FORT ST. VRAIN NUCLEAR GENERATING STATION

AMENDMENT TO FACILITY OPERATING LICENSE

Amendment No. 24  
License No. DPR-34

ATTACHMENT TO AMENDMENT NO. 24 TO  
FACILITY OPERATING LICENSE NO. DPR-34  
DOCKET NO. 50-267

FIGURE 7.1-1

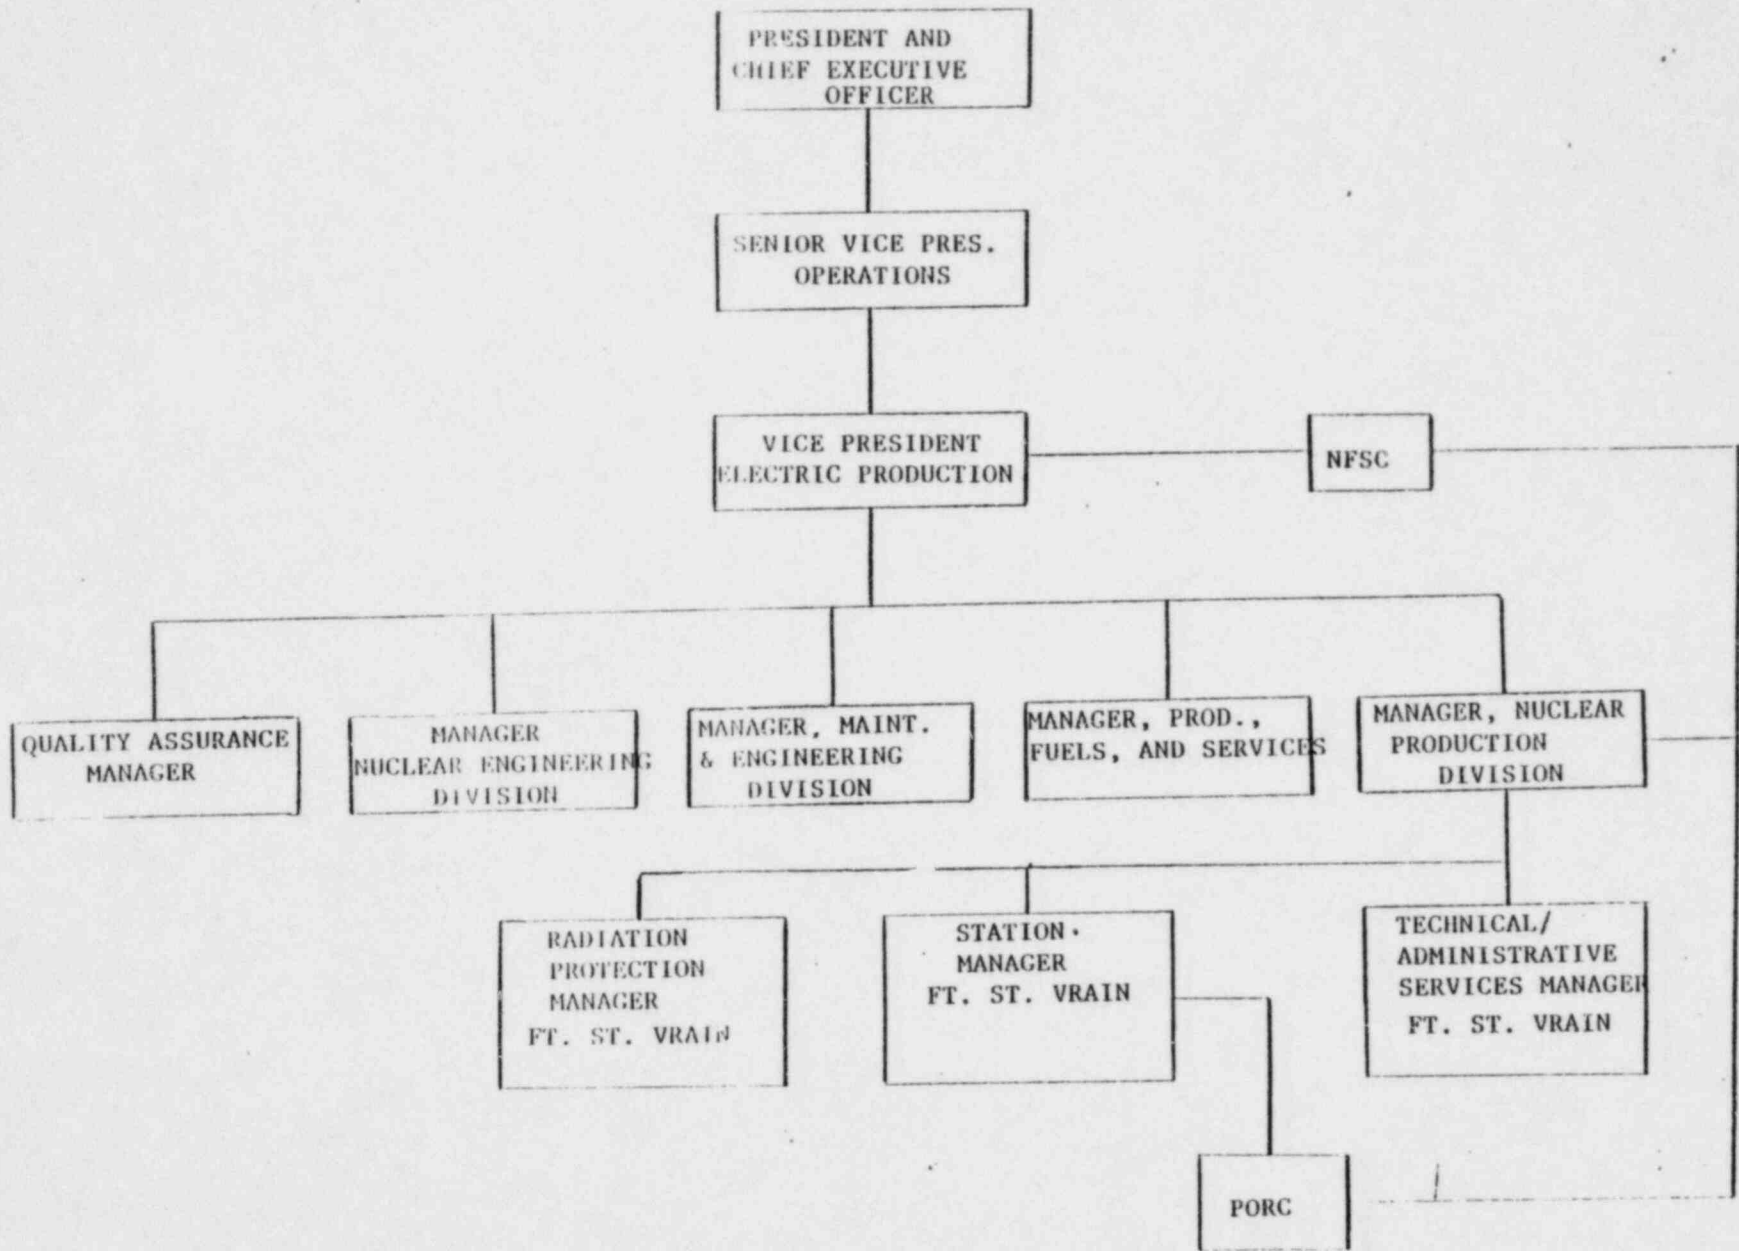
- a. In all matters pertaining to operation and maintenance of the plant and to these Technical Specifications, the Station Manager shall report to, and be directly responsible to, the Manager, Nuclear Production. The Administrative and Departmental Management Organization is shown in Figure 7.1-1.

FIGURE 7.1-2

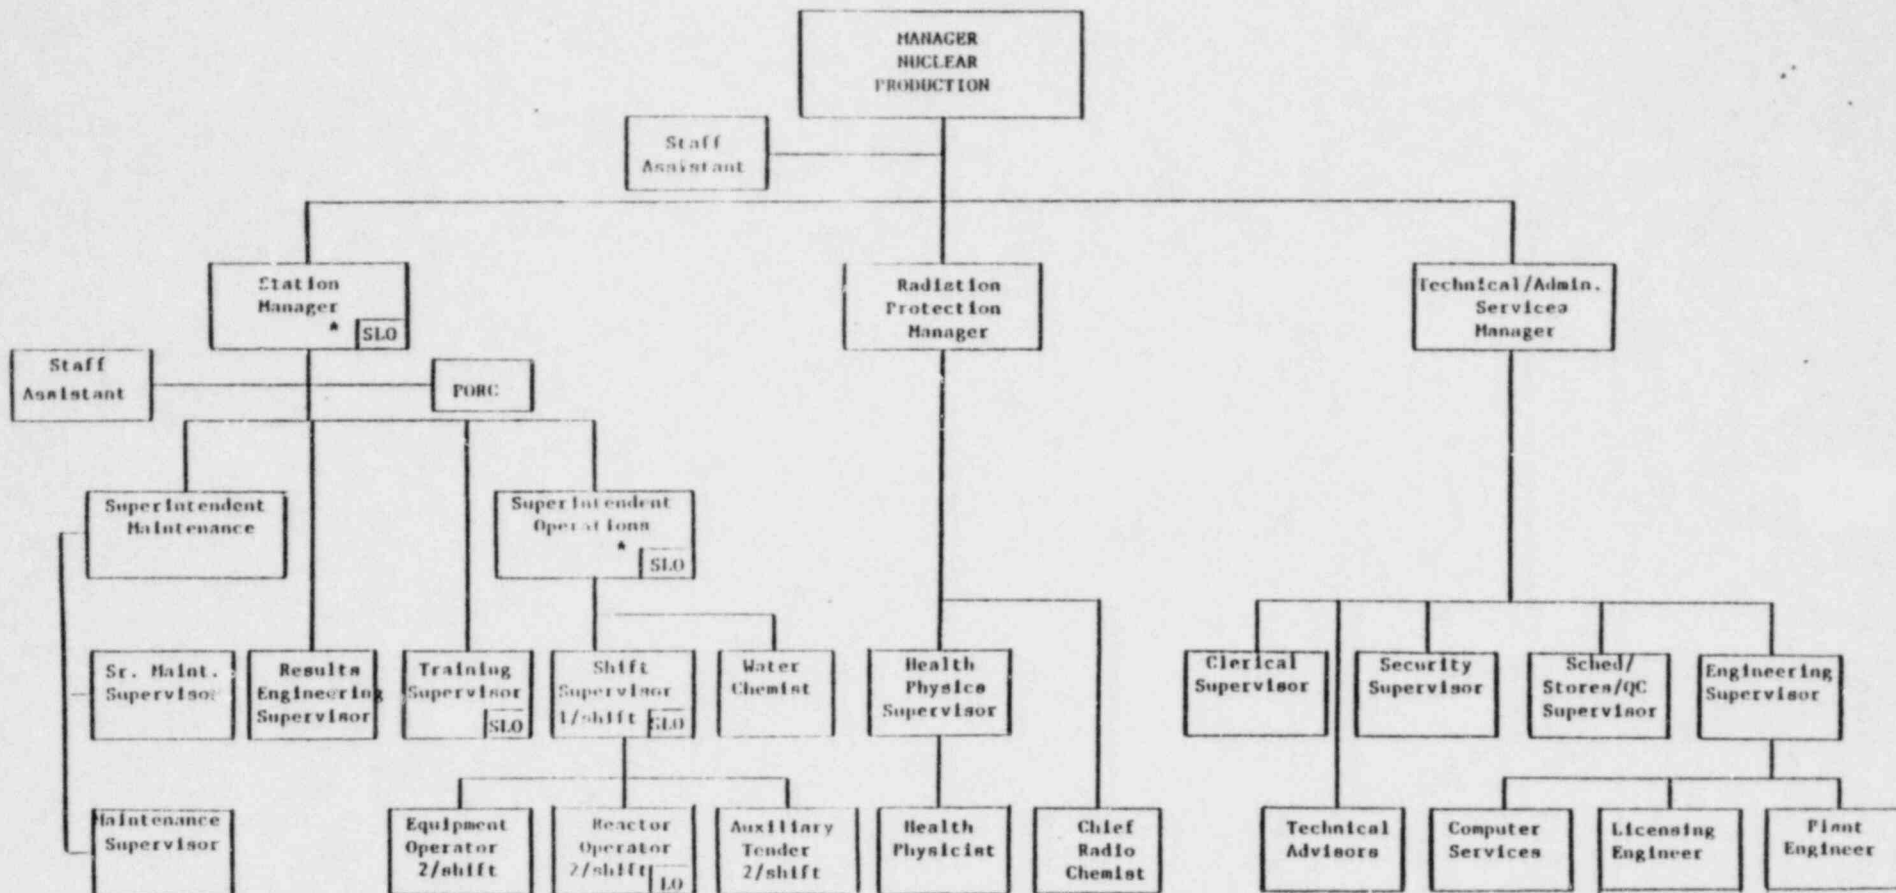
- (3) Assist the operations staff in applying the requirements of the Technical Specifications.
  - (4) Provide evaluation of Licensee Event Reports from other plants as assigned.
- d. Organization for conduct of operations of the plant is shown in Figure 7.1-2.
